UNITED STATES
NUCLEAR REGULATORY COMMISSION

The Commission has issued the enclosed Amendments Nos. 115, 115, and 112 to Licenses Nos. DPR-38, DPR-47 and DPR-55 for the Oconee Nuclear Station, Units Nos. 1, 2 and 3. These amendments consist of changes to the Station's common Technical Specifications (TSs) in response to your requests dated July 30, 1982 and September 10, 1982.

These amendments revise the TSs to reflect a Duke Power Company reorganization and personnel qualifications in the Administrative Controls Section and also correct the local leak testing requirements for certain containment penetrations.

SAFETY EVALUATION BY THE OFFICE OF NUCLEAR REACTOR REGULATION
SUPPORTING AMENDMENT NO. 115 TO FACILITY OPERATING LICENSE NO. DPR-38

Figure 6.1-2

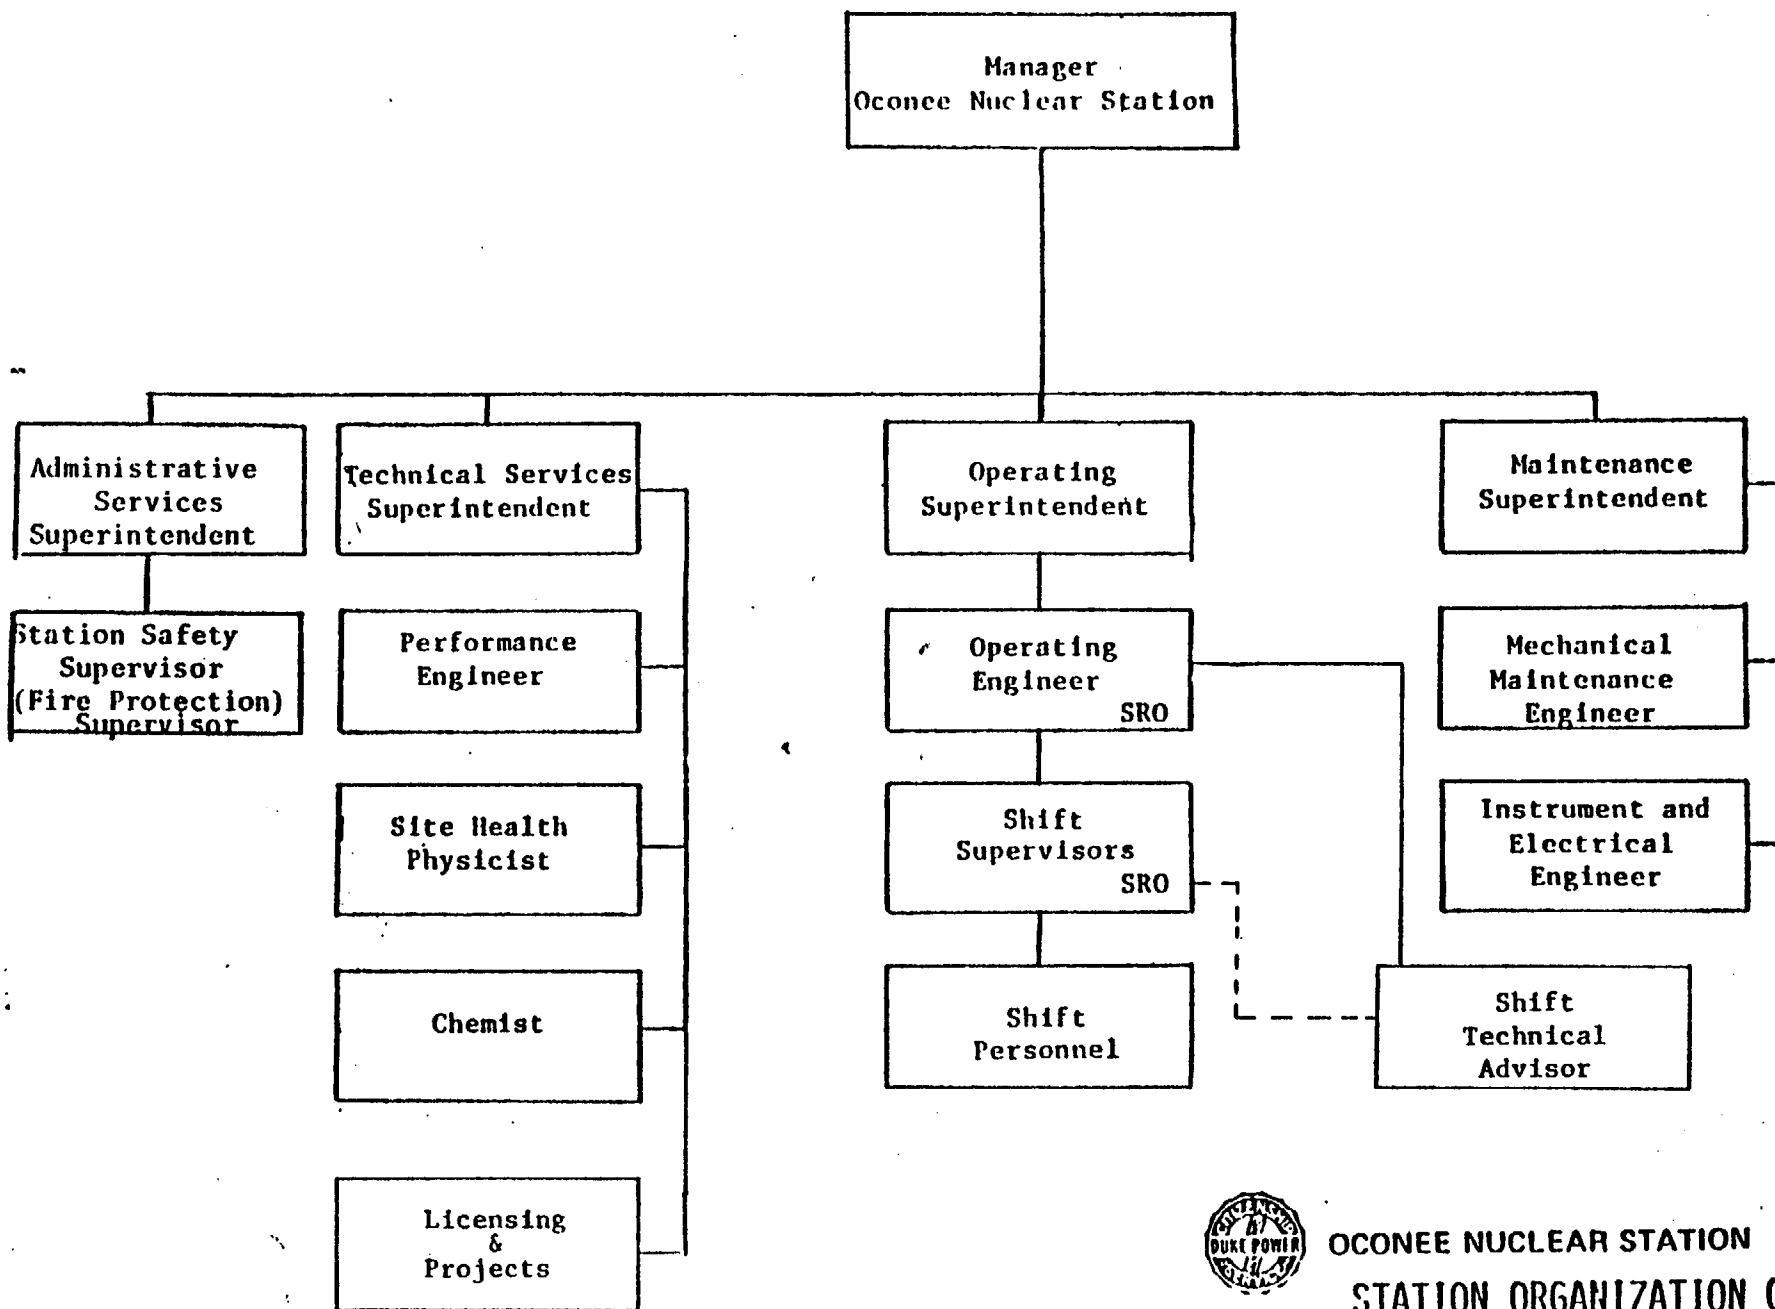
The current Oconee TSs indicate that the Manager, Oconee Nuclear Station, reports to the Manager, Nuclear Production, who in turn reports to the Vice President, Steam Production. The proposed reorganization divides the functions of the Vice President, Steam Production, into three new positions: Vice President, Nuclear Production; Vice President, Fossil Production; and Vice President, Production Support. Reporting to the Vice President, Nuclear Production, will be a General Manager, Nuclear Stations, to whom the Nuclear Station Managers will report. Also reporting to the Vice President, Nuclear Production, will be a Manager, Nuclear Reliability Assurance; Manager, Nuclear Safety Assurance; Manager, Nuclear Operation; Manager, Nuclear Maintenance; Manager, Nuclear Technical Services; Manager, Nuclear Engineering Services; Manager, Nuclear Administrative Services; and Manager, Nuclear General Services.

We consider that these proposed changes provide for better integration of those functions needed to support the operation of the nuclear station under a single high level corporate official and are acceptable. This is reflected in revised TS Figure 6.1-2 and numerous text changes.

- 6.1.1.2 In all matters pertaining to actual operation and maintenance and to these Technical Specifications, the station Manager shall report to and be directly responsible to the Vice President, Nuclear Production Department, through the General Manager, Nuclear Stations. The organization is shown in Figure 6.1-2.
